## Silicon Errata for the CYT4BF Series Rev. D

Document Revision: 2.2

Date: 2023-10-17

This document describes the errata for CYT4BF Rev. D Series of devices. Details include trigger conditions, scope of impact, available workarounds, and applicable silicon revisions. Contact your local Infineon Sales representative for further questions.

Figure 2. CAN Frame with  $DLC > 4$

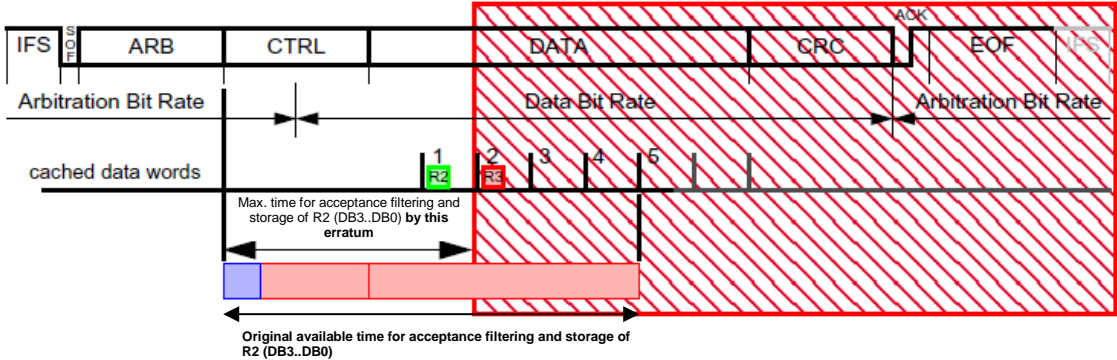
### 209. CAN FD sporadic data corruption (payload) in case acceptance filtering is not finished before reception of data R3 (DB7..DB4) is completed

Figure 2 shows how the available time for acceptance filtering and storage is reduced.

Due to condition 3) the issue occurs only sporadically. Use an end-to-end (E2E) protection (for example, checksum or CRC covering the data field) and add it to all messages in the CAN system, to detect data corruption in received frames.
